First Article Inspection

Project	Westgate Precision, Gloucester: HP-2214 bracket first article
Site or premises address	Unit 4, Tewkesbury Road Trade Park, Gloucester GL2
Client or organisation	Holloway Pump Systems Ltd
Record date	28 Sep 2026
Person completing the record	L. Prentice

Part number, description and serial or batch ID	HP-2214 motor mounting bracket, 6082-T6 aluminium, batch B0926, first-off part FA-01
Drawing and revision	HP-2214 rev D
Customer order and inspection requirements	Holloway PO 77310. Full first article inspection of all ballooned characteristics, report to go with the first delivery.
Reason for first article or repeat inspection	New part from a new supplier, first production batch
Material, special process and certificate references	Material certificate MC-60822 from the stockholder, anodising certificate AN-3317

Characteristic 3: 5

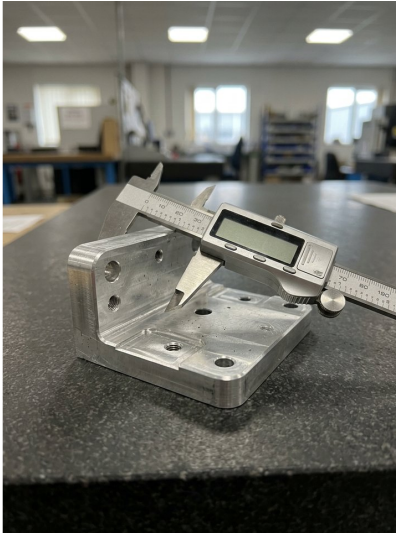
Drawing characteristic number	5
Nominal value, tolerance or requirement and unit	Mounting hole centres 80.00 ±0.05 mm
Measurement method and instrument reference	CMM-01, program HP2214-A
Actual measured value or observation	80.07 mm
Result	Outside stated requirement
Deviation and disposition reference	0.02 mm over the upper limit. NCR-WP-0412 raised, batch on hold, concession request CR-118 sent to the customer.

Action and evidence reference	Correct the hole position offset in CNC program HP2214-OP20 and measure the next part.
Person responsible	J. Ward, CNC setter
Target date	30 Sep 2026
Action status	Completed
Completion evidence	Offset corrected. Part FA-02 measured 80.01 mm on CMM-01, report CMM-FA02.
